APPLICATION NO.	FILING DATE	FIRST NAMED INVENTOR	ATTORNEY DOCKET NO.	CONFIRMATION NO.
10/666,478	09/19/2003	Wolfgang Schmid	5367-41	8862

Office Action Summary	Application No.	Applicant(s)	
	10/666,478	SCHMID ET AL.	
	Examiner	Art Unit	
	Phillip Nguyen	2828

DETAILED ACTION

FIG. 1B

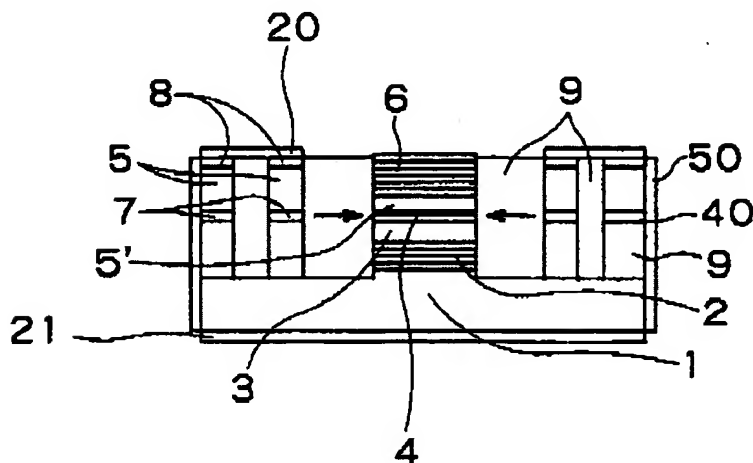
Claims 1-4 and 6-18 are rejected under 35 U.S.C. 102(e) as being anticipated by Kinoshita ('537).

With respect to claim 1, Kinoshita discloses in Fig. 1B a semiconductor laser apparatus having a vertical emitter (1-6) and having at least one pump laser (on the sides) for optically pumping the vertical emitter with the vertical emitter and the pump laser being monolithically integrated. It is inherent that a radiation emitting zone of the pump laser produces less heat /lower temperature than that of the vertical emitter because the vertical emitter provide more powerful laser beam than that of the pump laser.

With respect to claim 2, Kinoshita discloses both pump laser and vertical emitter are grown on a common substrate 1.

With respect to claims 3, Kinoshita discloses the pump laser and the vertical emitter being mounted on a common mount 21 which could be a heat sink.

With respect to claims 4, since the distances between the mount to both active layers of the pump laser and vertical emitter are the same, the thermal resistances depend on the material between the active layers and the common mount. In this case, the material between the vertical emitter includes Bragg reflectors 2 and cladding layer 3. The material between the layer 7 and 21 includes insulating material 9 which has thermal resistance less than the Bragg reflectors and cladding.

With respect to claims 6 and 7, Kinoshita discloses the one or two or more mirror layers 2 are arranged between radiation-emitting zone (upward) and the mount 21 wherein the mirror layers are Bragg mirror.

With respect to claim 8, Kinoshita discloses pump laser has an active layer 7, comprising active zone and the vertical emitter has an active layer 4 comprising its active zone with active layer of the pump laser and active layer of the vertical emitter having the same structure as shown in Fig. 1B.

With respect to claims 10 and 15, Kinoshita discloses the active layers of both pump laser and vertical emitter are formed jointly.

With respect to claims 11 and 16, Kinoshita discloses the radiation-emitting zone (as shown by the arrows) which is perpendicular to the direction of the main emission of the vertical emitter (for this case, it is upward direction).

With respect to claims 12 and 17, since the pump laser is formed on the edge and produces laser from its edge (shown by arrows), it is formed as an edge emitter.
